Well Name: SANTA MARIA 31/36 FED COM	Well Location: T20S / R27E / SEC 32 / SWNW / 32.5305524 / -104.3095761	County or Parish/State: EDDY / NM
Well Number: 626H	Type of Well: CONVENTIONAL GAS WELL	Allottee or Tribe Name:
Lease Number: NMNM19431	Unit or CA Name:	Unit or CA Number:
US Well Number:	Operator: MEWBOURNE OIL COMPANY

Notice of Intent

Sundry ID: 2801672

Procedure Description: Mewbourne Oil Company request that the following change be made to the Santa Maria 31/36 Fed Com #626H (API #30-015-55213): 1. Change well name f/ Santa Maria 31/36 Fed Com #626H (API #30-015-55213) to Santa Maria 31/36 Fed Com #626Y. 2. Request to skid of original wellbore Santa Maria 31/36 Fed Com #626H f/ 2475 FNL & 800 FWL (32) to 2481 FNL & 800 FWL (32) 3. Attached 3160-003, Plat, Drlg Program, Dir Plan corresponding with new SHL. 4. Reference Sundry ID: 2801667 for P&A of Santa Maria 31/36 Fed Com #626Y.

LOCATION VERIFICATION MAP

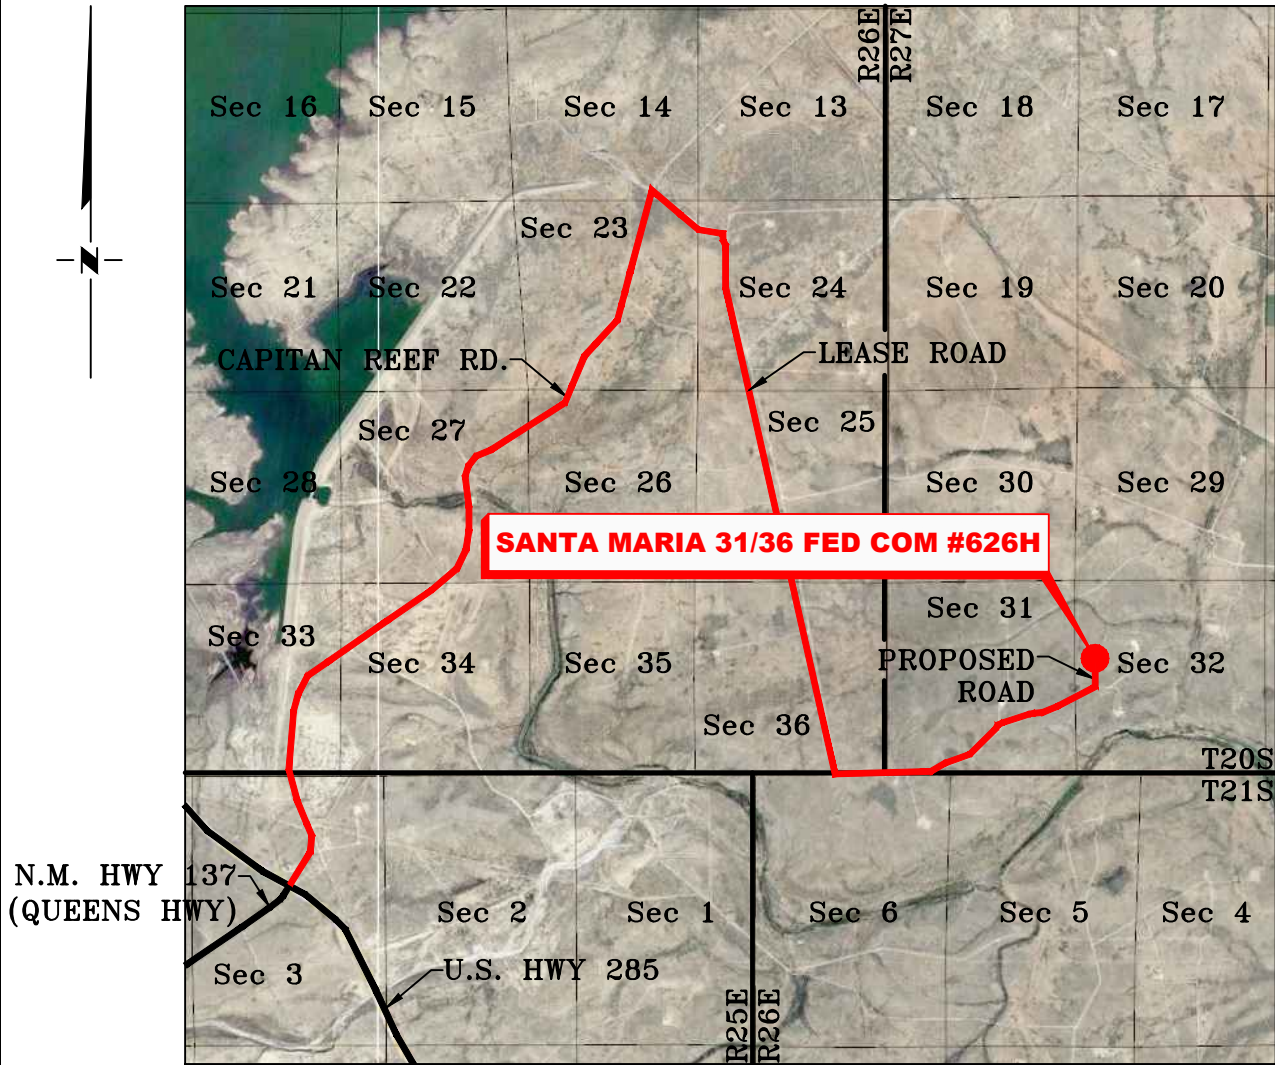
1	WELL MOVE	07/17/24
NO.	REVISION	DATE
JOB NO.: LS24010041R		
DWG. NO.: 24010041R-2

1. Change well name f/ Santa Maria 31/36 Fed Com #626H (API #30-015-55213) to Santa Maria 31/36 Fed Com #626Y.
2. Request to skid of original wellbore Santa Maria 31/36 Fed Com #626H f/ 2475 FNL & 800 FWL (32) to 2481 FNL & 800 FWL (32)
3. Attached 3160-003, Plat, Drlg Program, Dir Plan corresponding with new SHL.
4. Reference Sundry ID: 2801667 for P&A of Santa Maria 31/36 Fed Com #626Y.

MEWBOURNE OIL COMPANY
SANTA MARIA 31/36 FED COM #626H
(2481' FNL & 800' FWL)
SECTION 32, T20S, R27E
N. M. P. M., EDDY COUNTY, NEW MEXICO

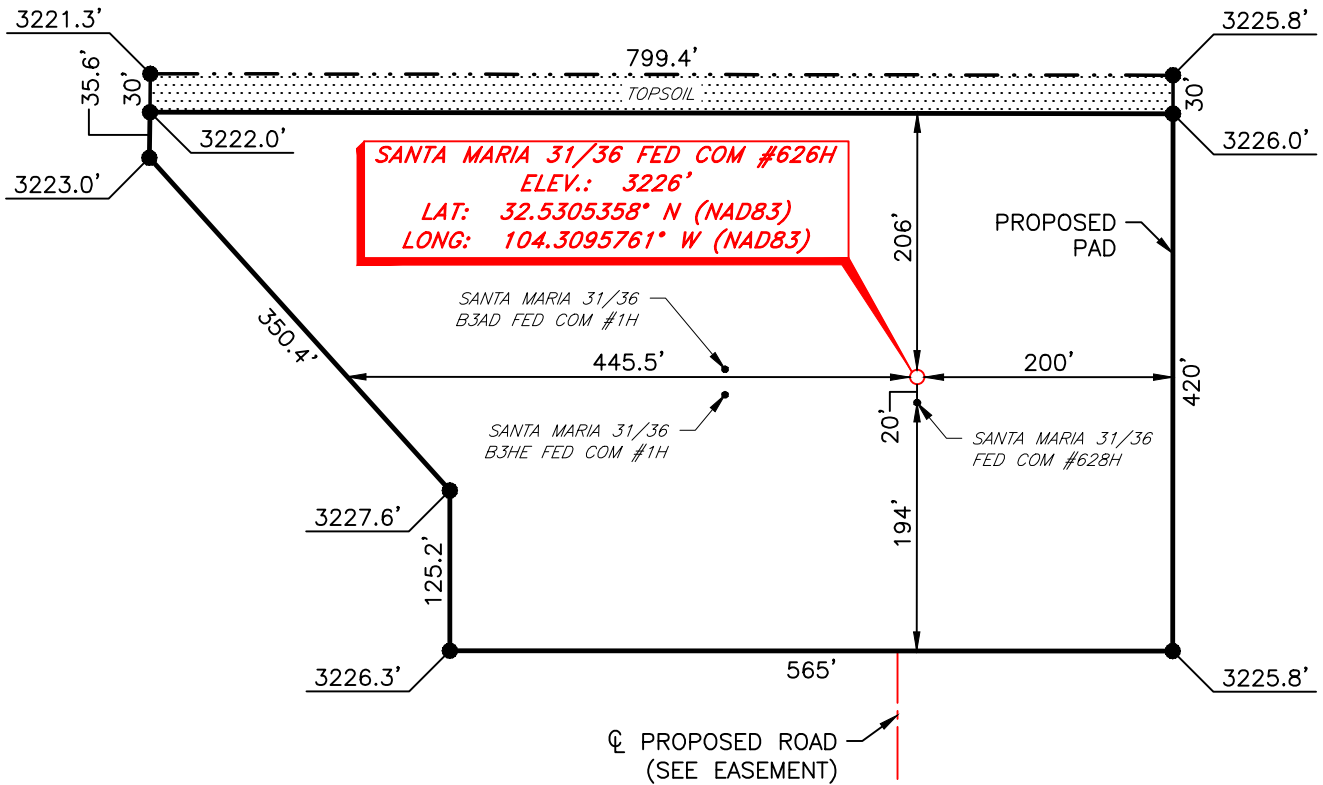
1	WELL MOVE	07/17/24
NO.	REVISION	DATE
JOB NO.: LS24010041R		
DWG. NO.: 24010041R-4
